Section 73 Planning Application Notes:

Project:
18021 Hammerstone Road Manchester

Sheet Name:
Proposed GA East Elevation

Project No. Orig. Zone Level Type Role Cls Dwg No. Rev
HRD-FRA-01-XX-DR-A-20-1207 **C05**

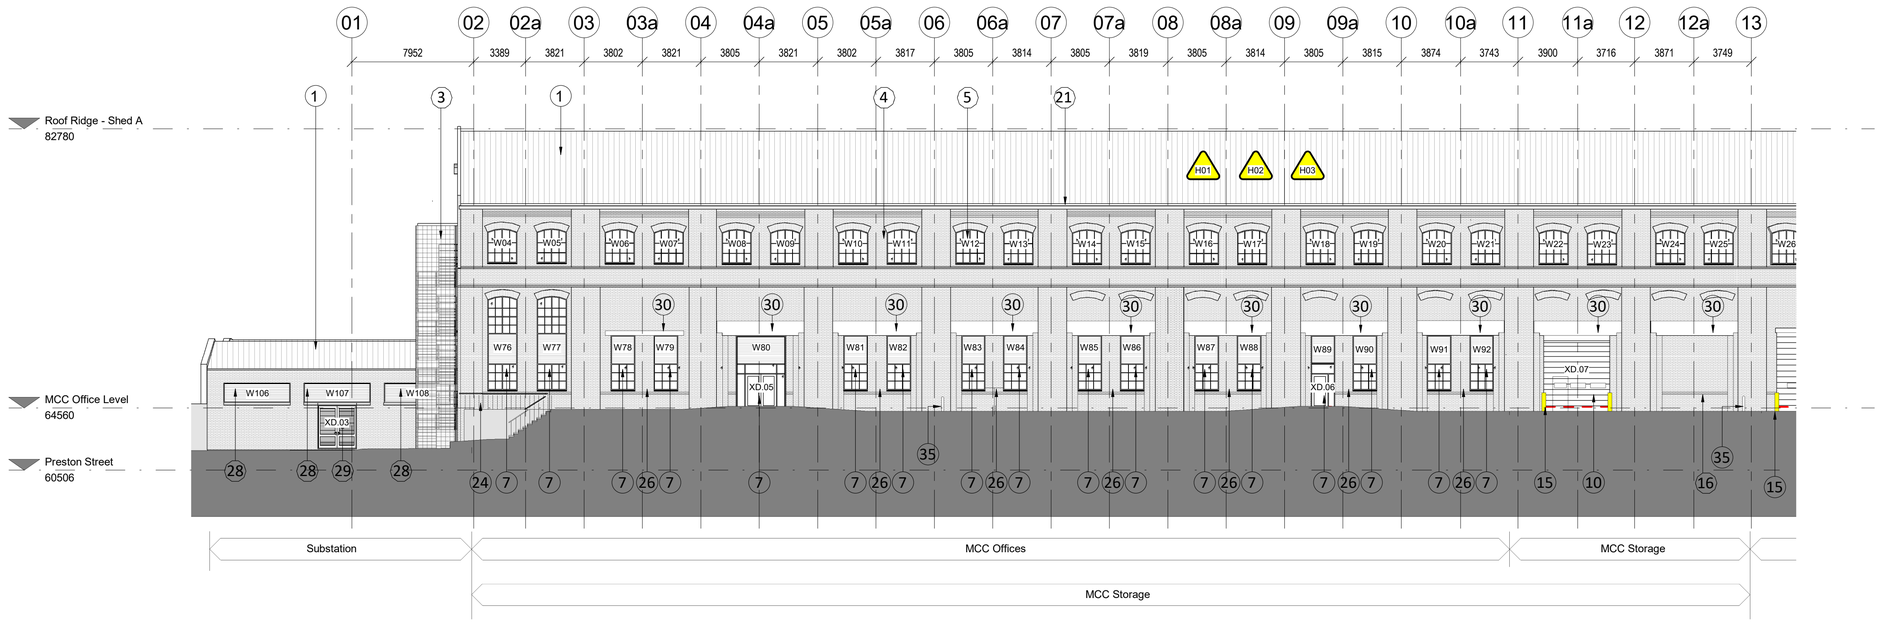
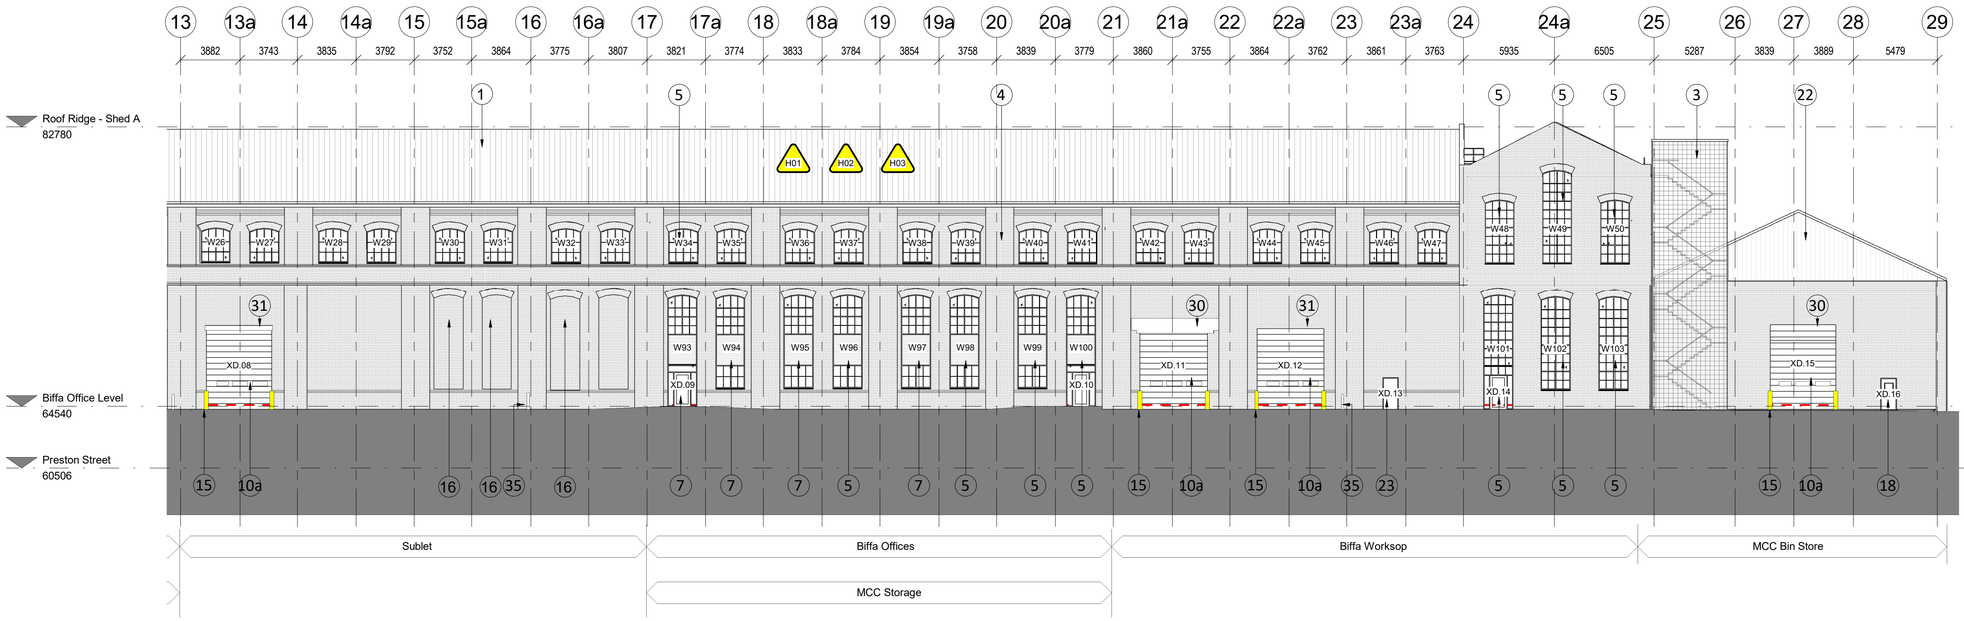
Revision H - Roof access walkway route updated

Revision F - Roof drainage changed from a gravity to a siphonic system, external rwps' omitted from GL'a A & G,

Note: existing upvc gravity rainwater pipes on GL's E, 24 & 25 replaced with new aluminium rwp
Colour: Black Grey RAL 7021
